Welcome
Dumbarton Bridge
Contractors Technical Outreach

Addendum 1 – Major Changes

DUMBARTON BRIDGE *Seismic Safety Retrofit Project*

Contractors Technical Outreach

PLAN
PIER 13 TO PIER 18
1" = 40'

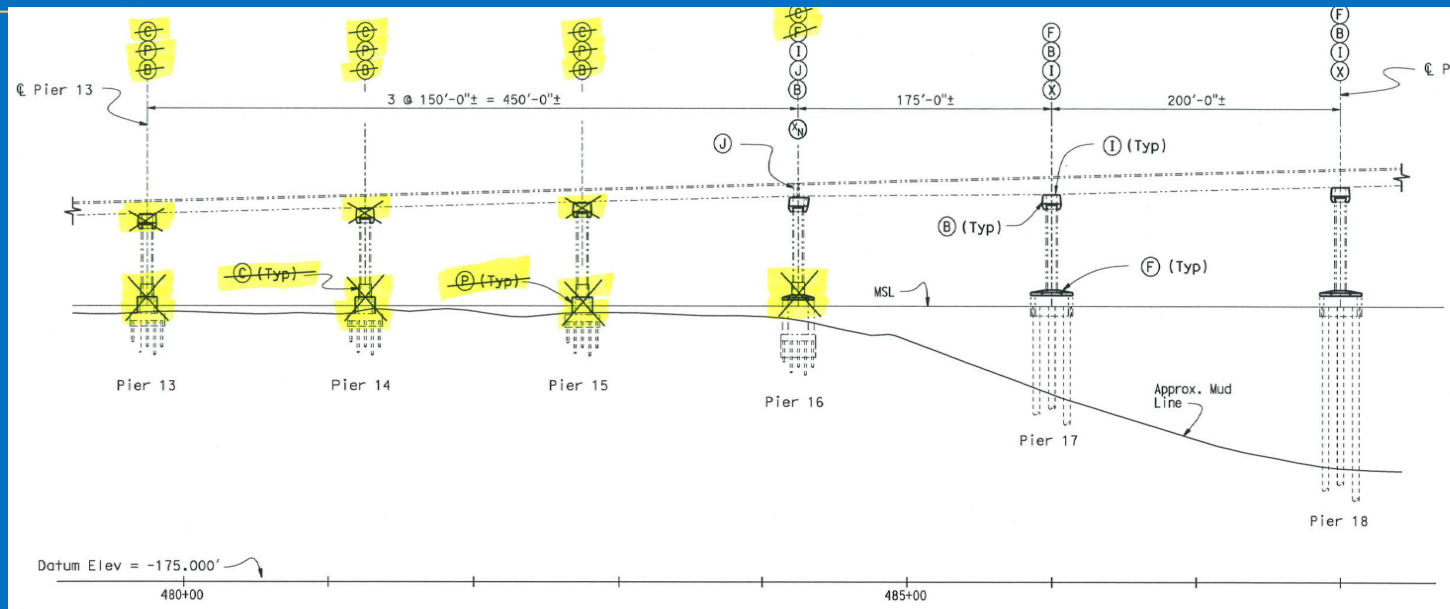
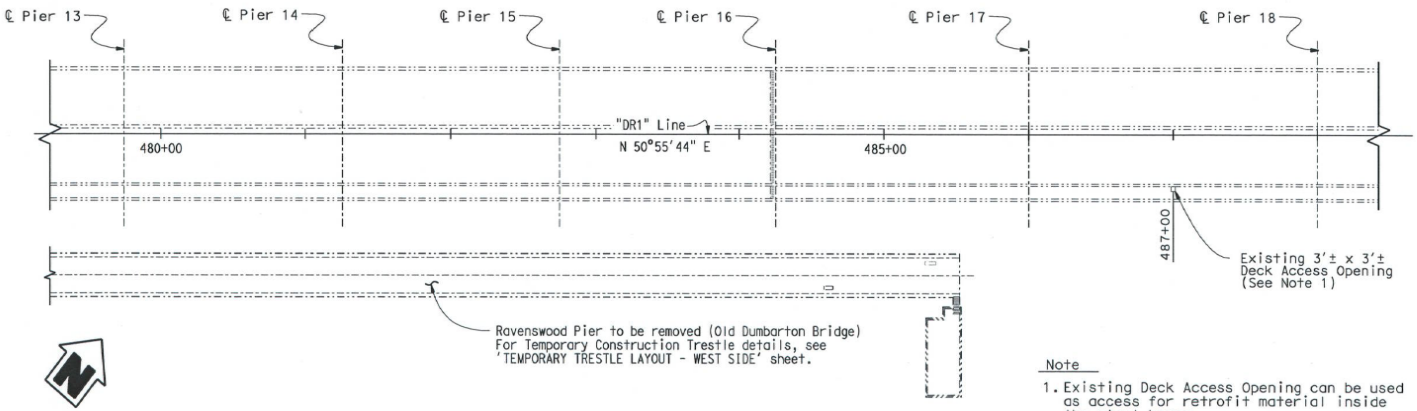
LEGEND
- Ⓕ Footing Overlay
- ~~Ⓒ Column Retrofit~~
- Ⓑ Pier Cap Retrofit
- Ⓙ Seismic Joint
- Ⓘ Isolation Bearing
- ~~Ⓟ Footing Pedestal Retrofit~~
- Ⓧ Steel Cross Frame Retrofit
- Ⓧ_N New Steel Cross Frame

1. For Utilities relocation, see 'ROAD PLANS'
2. Construction sequence is shown for Pier 16, Pier 31 is similar and under separate bridge closure.
3. ~~Contractor shall construct cofferdams where necessary to dewater the retrofit work area.~~

PLAN
PIER 29 TO PIER 34
1" = 40'

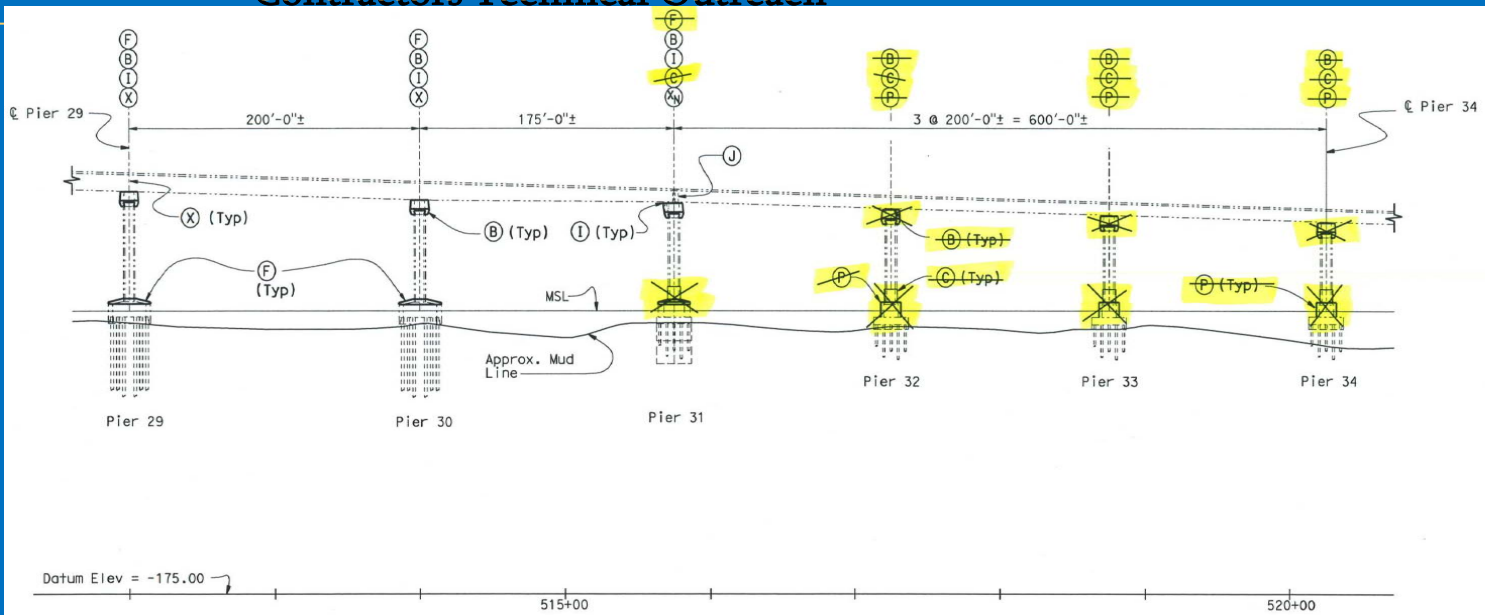
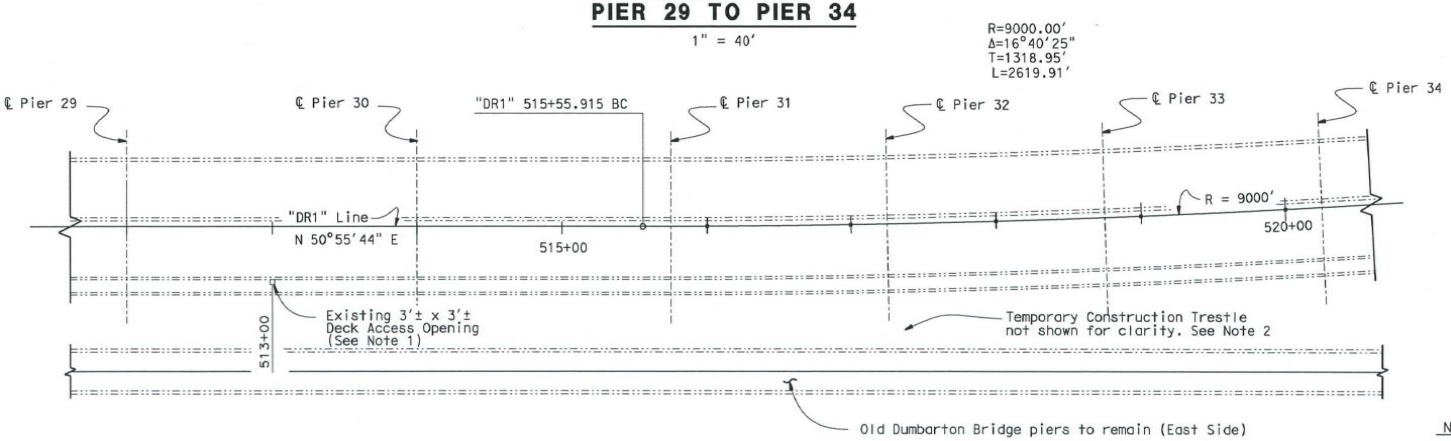
- (F) Footing Overlay
- ~~(C) Column Retrofit~~
- (B) Pier Cap Retrofit
- (J) Seismic Joint
- (I) Isolation Bearing
- (X) Steel Cross Frame Retrofit
- ~~(P) Footing Pedestal Retrofit~~
- (XN) New Steel Cross Frame

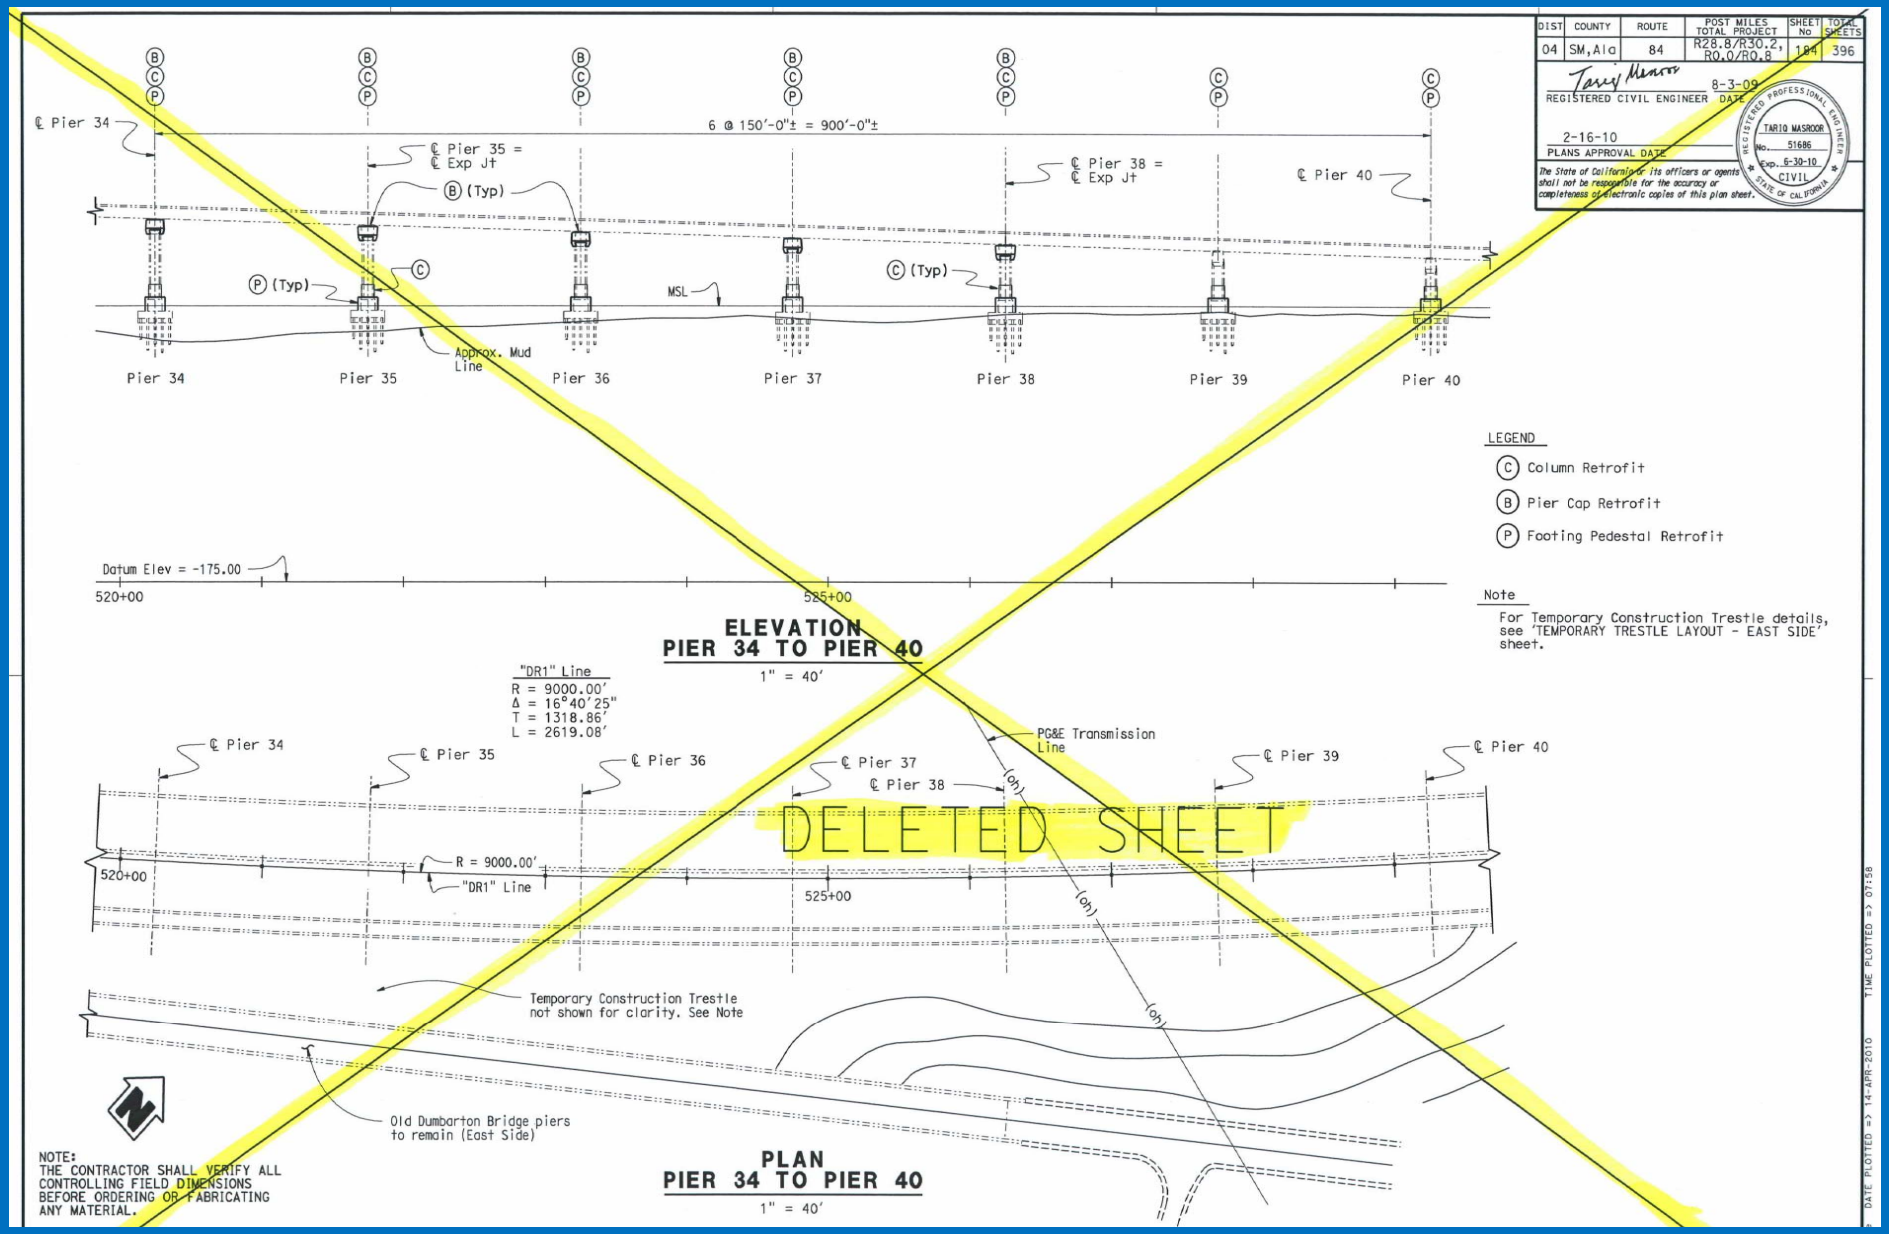
DELETED SHEET
ELEVATION
PIER 34 TO PIER 40
1" = 40'
PLAN
PIER 34 TO PIER 40
1" = 40'
6 @ 150'-0"± = 900'-0"±
℄ Pier 34
℄ Pier 35 = ℄ Exp Jt
℄ Pier 38 = ℄ Exp Jt
℄ Pier 40
Pier 34
Pier 35
Pier 36
Pier 37
Pier 38
Pier 39
Pier 40
MSL
Approx. Mud Line
Datum Elev = -175.00
520+00
525+00
"DR1" Line
R = 9000.00'
Δ = 16°40'25"
T = 1318.86'
L = 2619.08'
PG&E Transmission Line
Temporary Construction Trestle not shown for clarity. See Note
Old Dumbarton Bridge piers to remain (East Side)
LEGEND
Column Retrofit
Pier Cap Retrofit
Footing Pedestal Retrofit
Note
For Temporary Construction Trestle details, see 'TEMPORARY TRESTLE LAYOUT - EAST SIDE' sheet.
NOTE:
THE CONTRACTOR SHALL VERIFY ALL CONTROLLING FIELD DIMENSIONS BEFORE ORDERING OR FABRICATING ANY MATERIAL.
DIST 04
COUNTY SM, Ala
ROUTE 84
POST MILES TOTAL PROJECT R28.8/R30.2, R0.0/R0.8

PLAN
PIER 40 TO PIER 44
1" = 40'

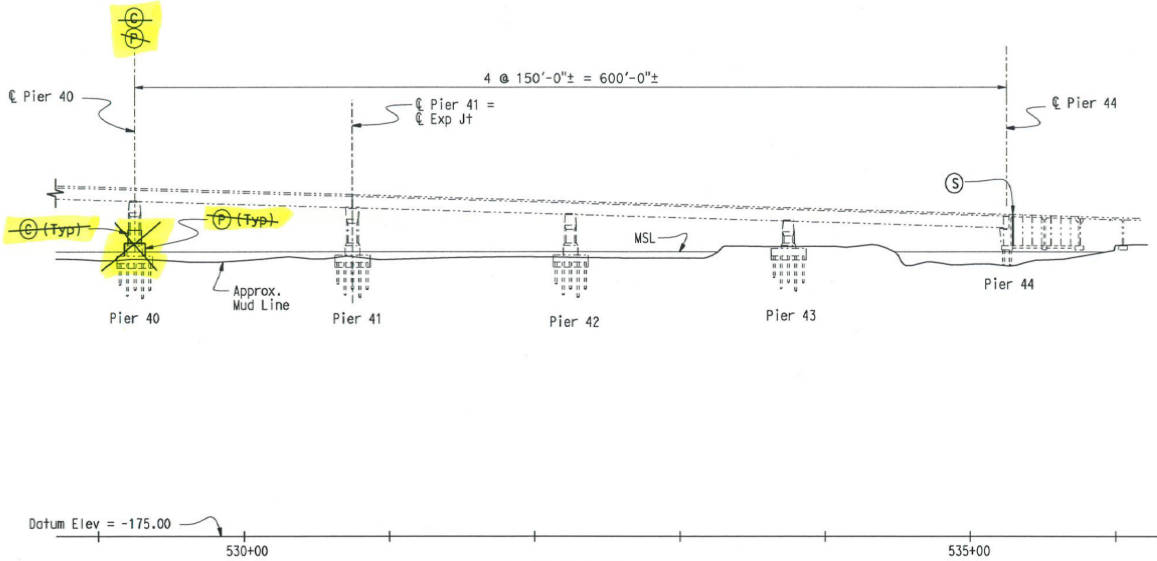
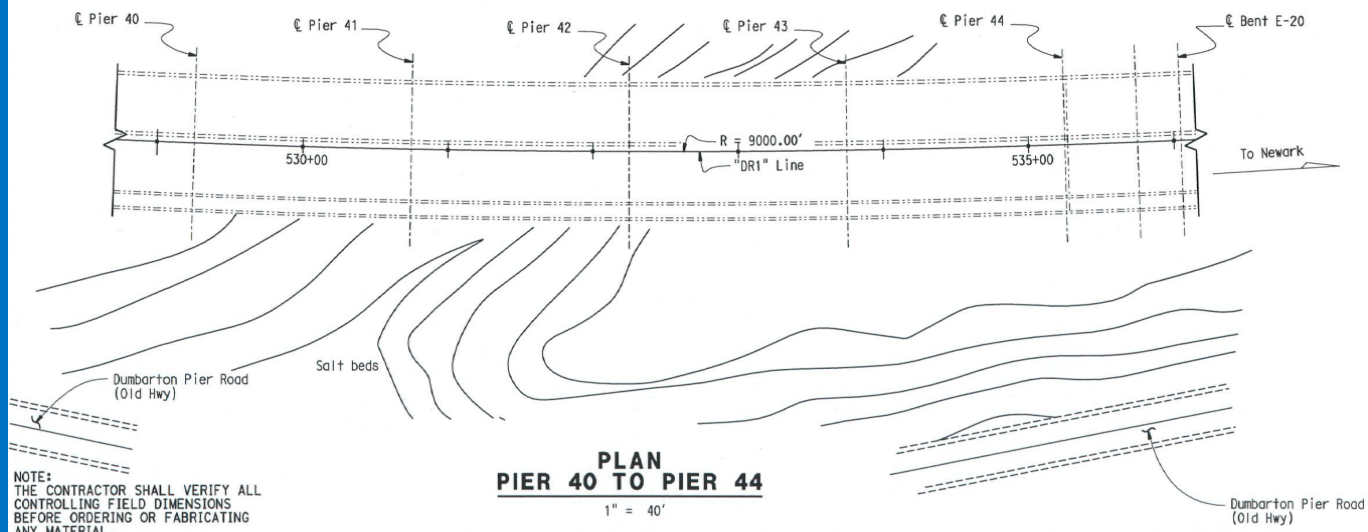
LEGEND
- ~~C Column Retrofit~~
- ~~P Footing Pedestal Retrofit~~
- S Backwall Seat Retrofit

WEST & EAST APPROACH SPANS
DUMBARTON BRIDGE SEISMIC RETROFIT PROJECT
PIER 5 -15, 32 - 40 RETROFIT
PIER DETAILS

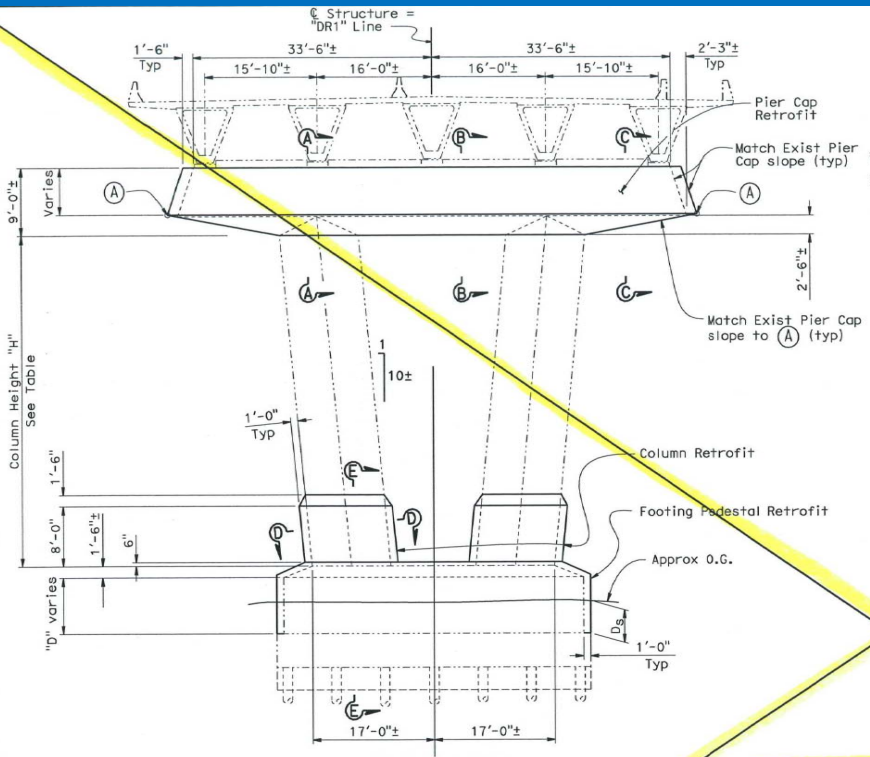
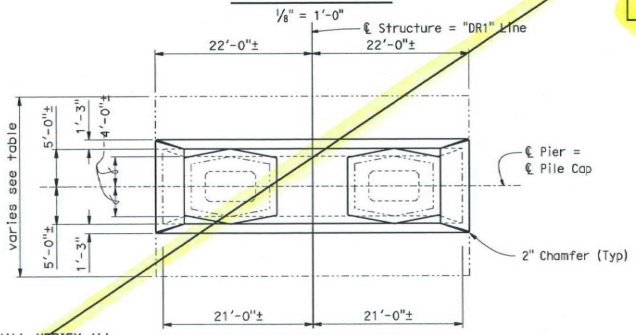
DELETED SHEET

TYPICAL SECTION = HINGE 21 & 25 MR=7½"

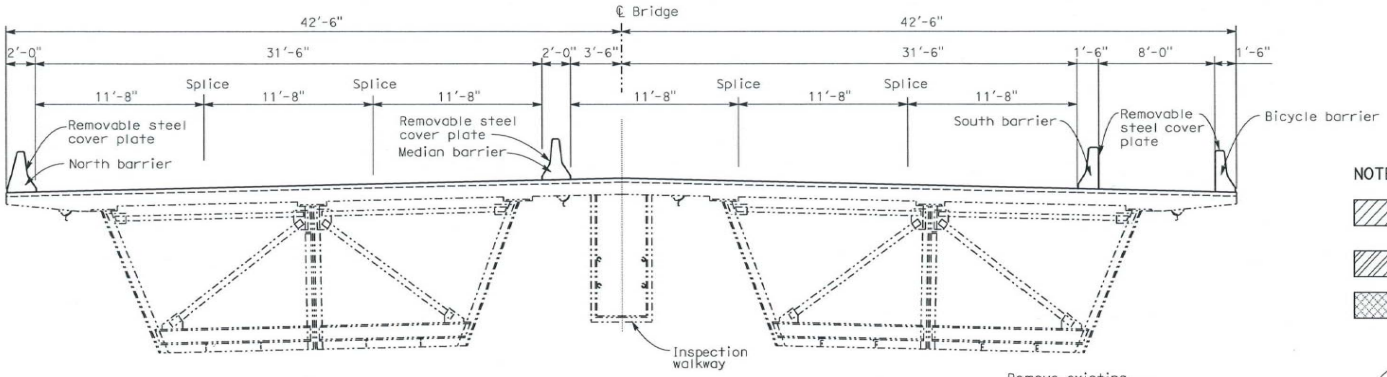
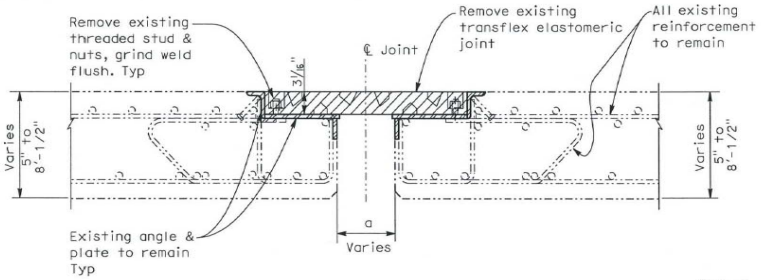
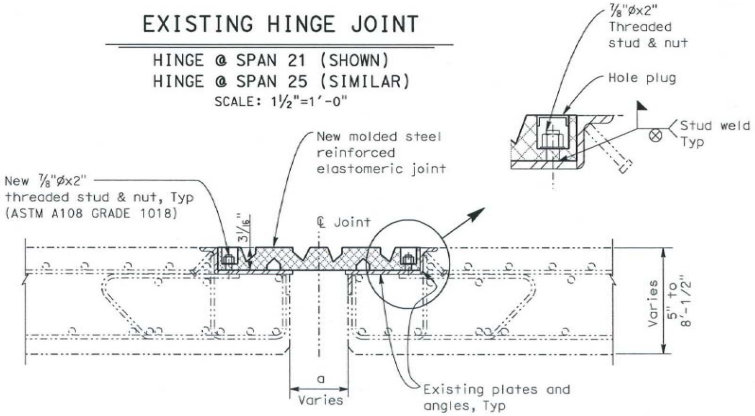
1. Eliminate retrofit work in approach spans (Piers 5-15 and 32-40 and portion of 16 & 31)
2. Add Hinge Joint Seal Replacement (Hinge 21 and 25)
3. Make miscellaneous plan revisions
4. Revise specifications, bid opening date
5. Revise item quantities, cost estimate and working days

- Indicates limits of remove existing transflex elastomeric joint & threaded stud.
- Indicates steel shapes, plates and angles
- Indicates new transflex elastomeric joint

Description of Bridge

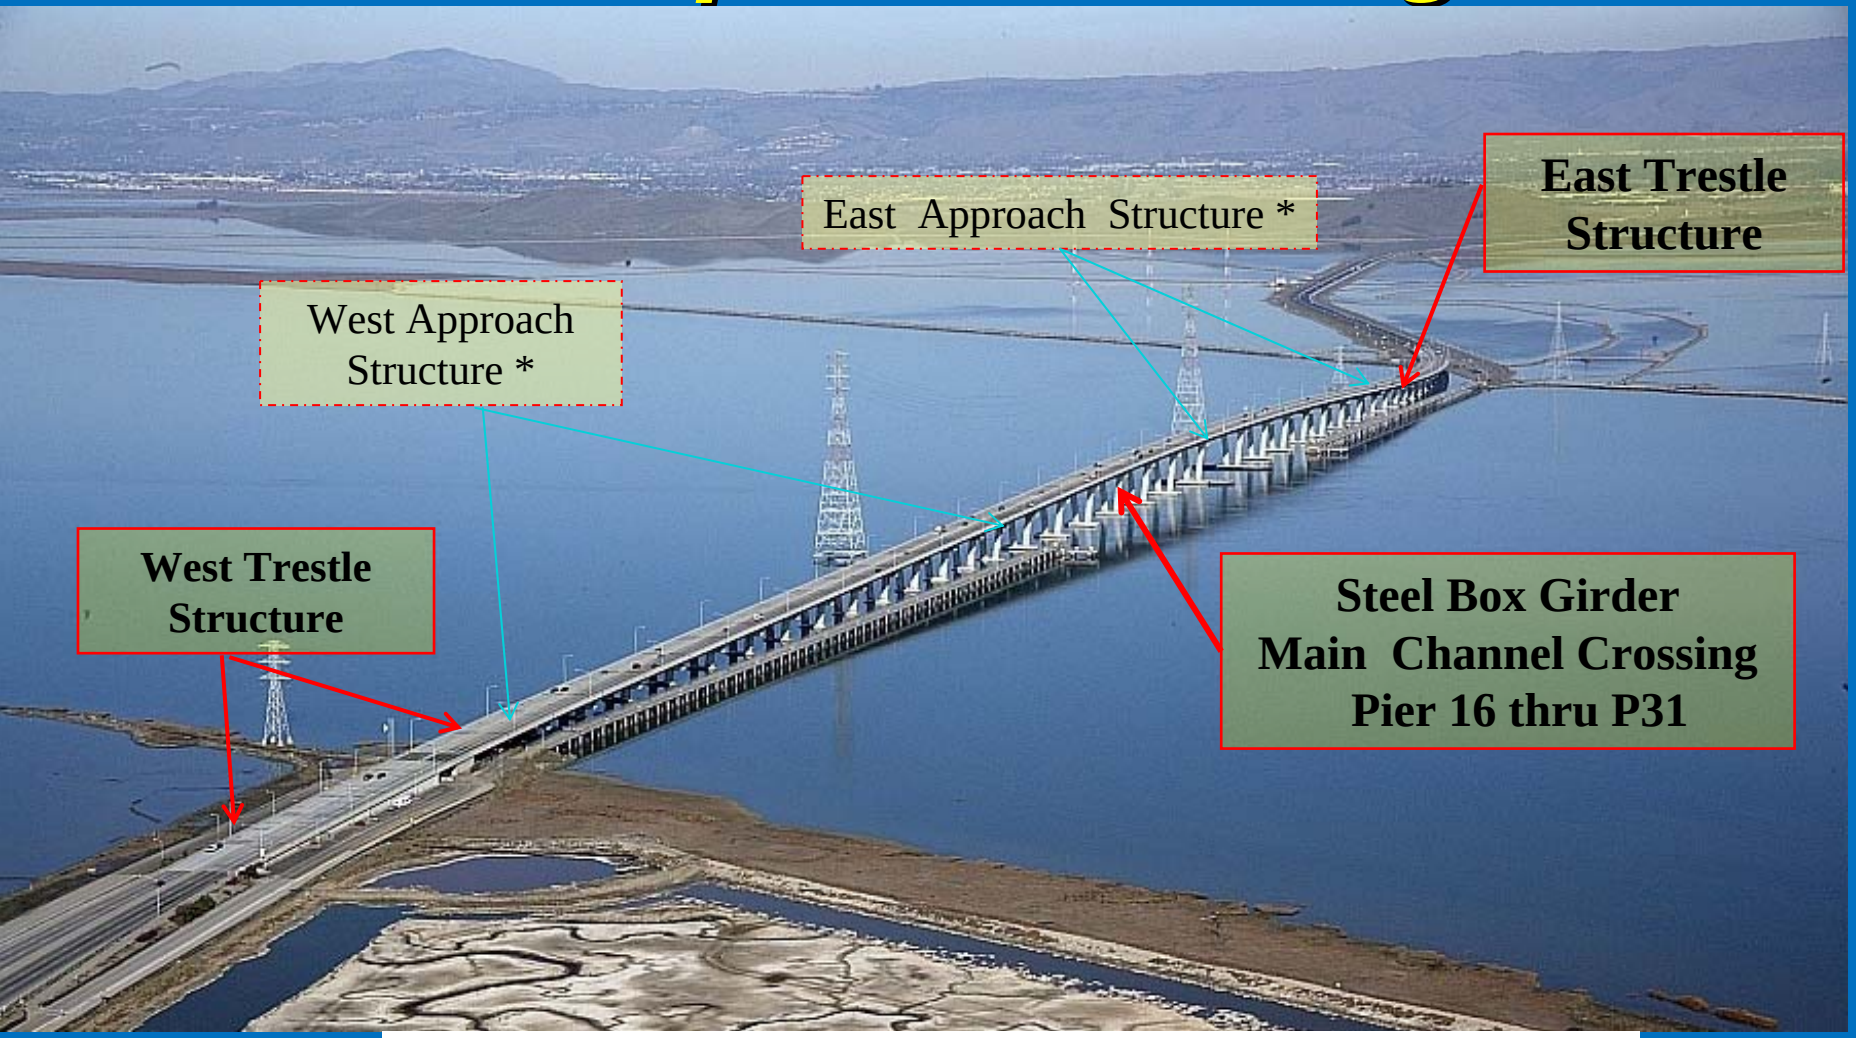
* East and West Approaches Retrofit Removed per Addendum 1 (Bent Cap Bolsters, and Column/Pedestal Jackets)
